Source: Nokia

## Modifications to RACH transmission due to chiprate change

In 677, "Impact of OHG harmonization recommendation on UTRA/FDD and UTRA/TDD", it was proposed that there would be 15 access slots per 2 frames. This paper contains the text proposal to TS 25.211 based on that assumption.

Figure 2. RACH access slot numbers and their spacing.

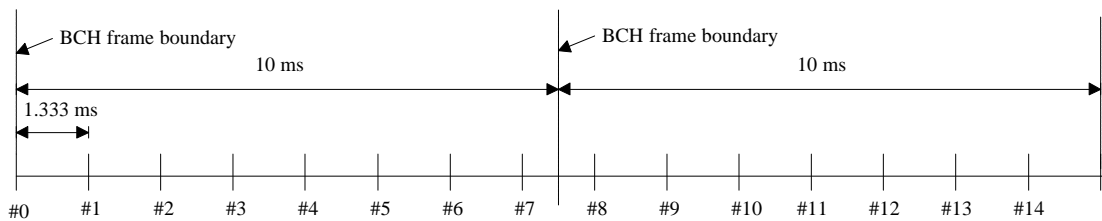
The random-access transmission is based on a Slotted ALOHA approach with fast acquisition indication. The UE can start the transmission at a number of well-defined time-offsets, relative to the frame boundary of every second frame of the received BCH of the current cell. The different time offsets are denoted *access slots*. There are 15 access slots per two frames and they are spaced  $1.25 \cdot 20/15 = 1.333$  ms apart, as illustrated in Figure 2 Figure 2 shows the access slot numbers and their spacing to each other. Information on what access slots are available in the current cell is broadcast on the BCH.

*Figure 3* *Figure 4*: Structure of the random-access transmission.

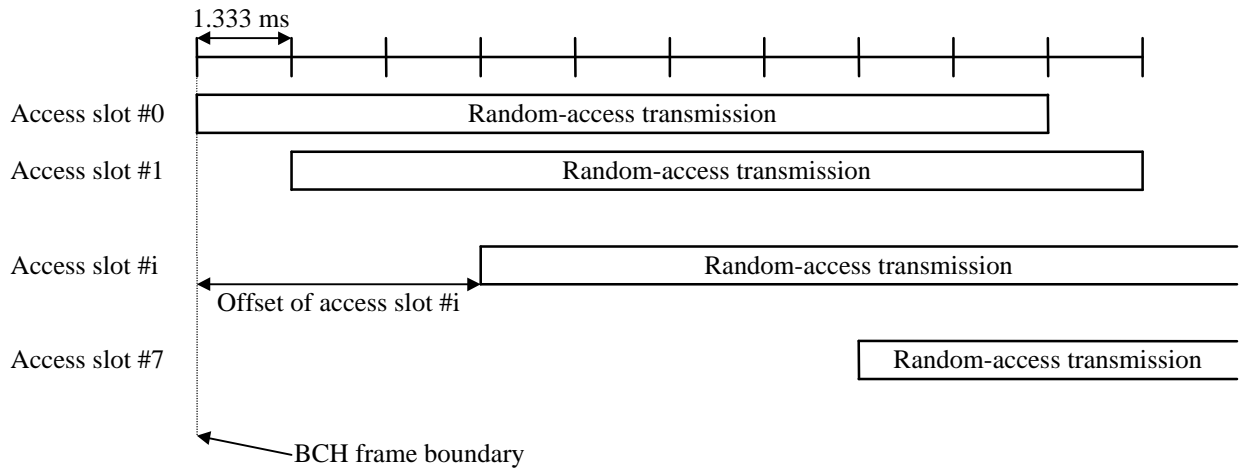
The structure of the random-access transmission of *Figure 3* *Figure 2*, is shown in *Figure 4* *Figure 3*. The random-access transmission consists of one or several *preambles* of length 1 ms and a *message* of length 10 ms.
